RE: Volvo Recall 218
Certain Model Year 2010 - XC60

VOLVO				TITLE: Recall 218: Fuel Line Rail Cover Inspect / Reattach		GROUP: 23	NO: 218
						ISSUING DEPARTMENT: Warranty	
Service Manager Bulletin				Model Year 2010 - XC60		CARMARKET: United States, Canada	
						REFERENCE BULLETINS: PB 23-218 RTJ 22278	
Service Person- nel: read and initial.	SERVICE MANAGER	SERVICE WRITER	WARRANTY ADMINISTRATOR	Page 1 of 2

SUBJECT Recall 218: Fuel Line Rail Cover Inspect / Reattach MODEL YEAR 2010 - XC60				GROUP 23		NO 218	
				MARKET United States, Canada		PAGE 1 of 1	
COPY TO / CIRCULATIONS (PLEASE INITIAL)							
GENERAL MGR	PARTS MGR	SERVICE MGR	SALES MGR	DATE	YEAR	MONTH	DAY
					2009	12	17

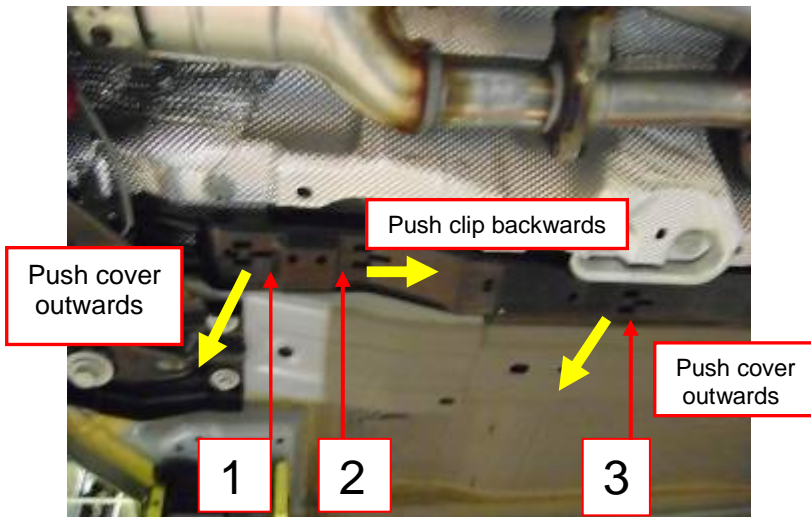
Inspect clips on front of fuel rail cover.

Check for loose clips by gently pulling down.

If clip 1 is not secure push the rail outwards to align over body stud.

If clip 2 is not secure slide clip (not cover) backwards to align over body stud.(see pic.below)

If clip 3 is not secure push the rail outwards to align over the body stud.
